RE: *PDC17-047 & PD18-015 – Planned Development Zoning and Planned Development Permit for Real Property Located at 1330, 1388 and 1410 S. Bascom Avenue (Item 10.2 - September 10, 2019 City Council Agenda)*

**Re: SOUTH BASCOM GATEWAY STATION
SCH 2019069109 — *Mitigated Negative Declaration***

San Jose Vasona Quiet Zone Diagnostic Review Meeting Notes (DRAFT)

Bascom Station North (Pedestrian)

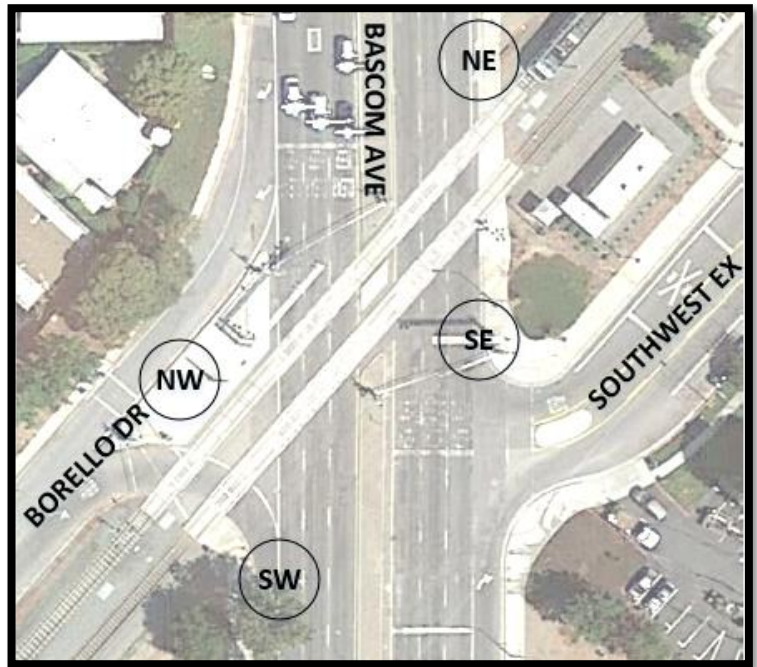
1. Crash History 2007 - 2019: none
2. Land Uses: multifamily residential; development proposed on the triangular parcel to the northwest of Bascom LRT Station will provide pedestrian access to both station entrances; the development includes 600 residential units, 300,000 square feet of commercial space, and a 200,000 square feet office building

3. CPUC submitted a comment letter to City of San Jose Planning on 8/5 in which it recommended that the proposed development on the northwest quadrant:

- Install Commission Standard 9 pedestrian automatic gates with EXIT swing gates and channelization at both pedestrian station crossings.
 - Relocate the detectable warning strips outside of the swing gates at the two pedestrian station crossings.

4. Consider standard sign set up at all station crossings; perhaps move "Look Both Ways" and "No Train Horn" signs to swing gates
5. Crossbuck signs on posts need to be rotated to face pedestrians coming from outside the crossing- rotate or add another crossbuck sign facing the nearest approach

6. Replace signs damaged with graffiti (immediate action item)
7. Swing gates need maintenance (immediate action item)
8. Striping across tracks to delineate edge of pedestrian path needs to be refreshed

9. Relocate detectable warning strips to outside of crossing
10. Future development on the west side of the rail corridor will need a Commission Standard #8 flasher on west side of tracks

11. Blue ENS should be relocated to the post with the crossbucks as is typical at other ped crossings
12. There is a "Look Both Ways" sign in between the tracks; consider removing, or relocate to swing gate
